ISSUE: Permit to Demolish (partial) and Certificate of Appropriateness for alterations (addition)

LOCATION: Old and Historic Alexandria District
729 South Pitt Street

BAR#2024-00222 & BAR#2024-00234
729 S Pitt Street

I. APPLICANT'S PROPOSAL

Figure 1. Existing one-story rear addition viewed from backyard (left) and public alley (right).

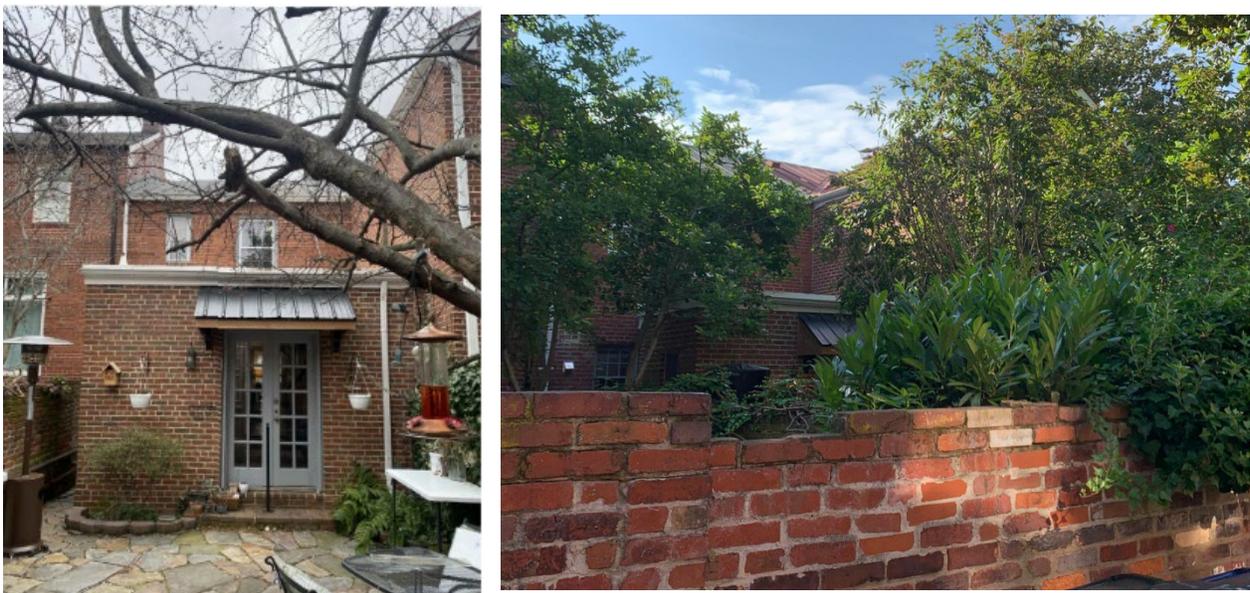
The applicant requests a Permit to Demolish (partial) to capulate part of the one-story rear (west) addition by demolishing the roof and encapsulating wall area, and a Certificate of Appropriateness to construct a porch addition on top of the existing rear addition (Figure 1).

The analysis of the standards indicated above relate only to the specific portions of the building proposed for demolition/capsulation, not the overall building. In the opinion of staff, none of the criteria for demolition and capsulation are met and the Permit to Demolish/Capsulate should be granted. The select portions of the building proposed for demolition/capsulation are not themselves of unusual or uncommon design. The historic integrity of the structure will be largely unaffected by the proposed work.

Figure 2. Proposed rear (west) elevation.

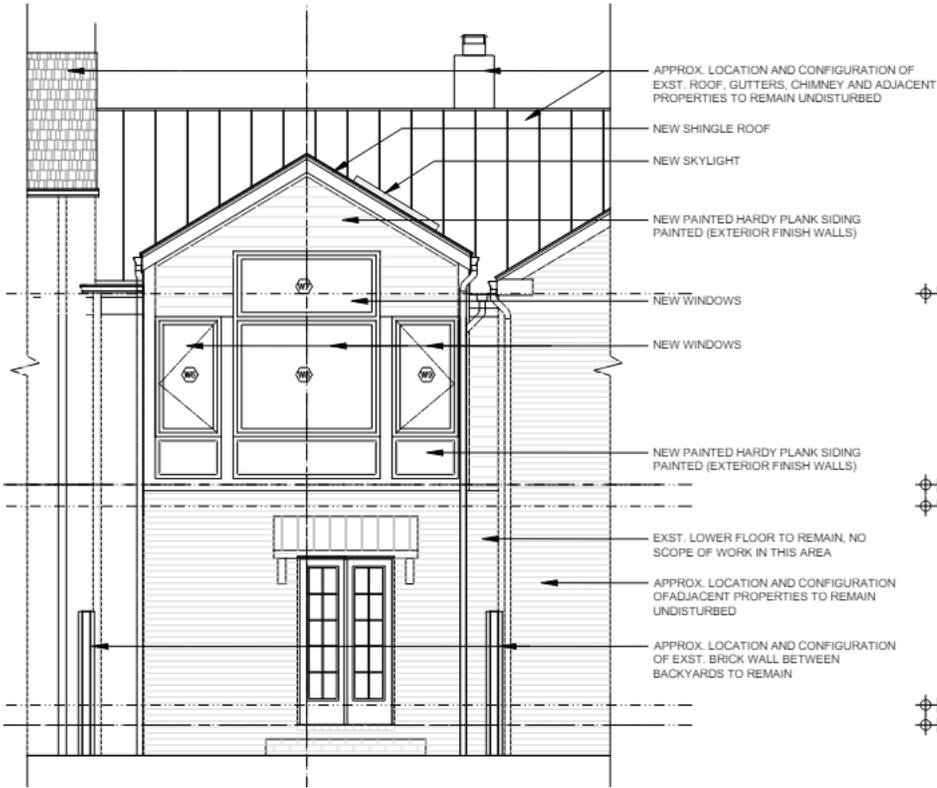
The new addition will be 194 square feet in area. Figures 2 and 3 show the proposed rear (west) and side (north) elevations of the addition. The addition will have painted Hardie plank siding, a new shingle roof, new skylight, and new windows. The plans note that all window glass will be clear, Low-E with a maximum U-factor of 0.30. The skylight glass will have a maximum U-factor of 0.55. There will be a new HVAC condenser unit mounted to the exterior north wall of the first floor of the rear addition. Otherwise, the existing first floor of the rear addition, as well as the existing roof of the main massing, will remain unchanged.

According to the *Design Guidelines*, “As a general rule, the stylistic characteristics of additions to residential buildings should reflect the historical architectural styles found within the historic districts” and “Additions must be designed so that they are compatible with both the architectural character of the existing house and the immediate neighborhood.” In the opinion of staff, the style of the proposed addition is sympathetic to both the 1941 massing and the 1965 addition. The applicant proposes to use high-quality modern materials that are historically appropriate. The new addition will only be visible from the public alley at certain angles and will blend in with the existing architecture.

- The applicant must work with staff to submit window specifications that comply with the guidelines found in the *BAR Policies for Administrative Approval*.
- The roof of the new addition must use architectural composition shingles, rather than 3-tab shingles.
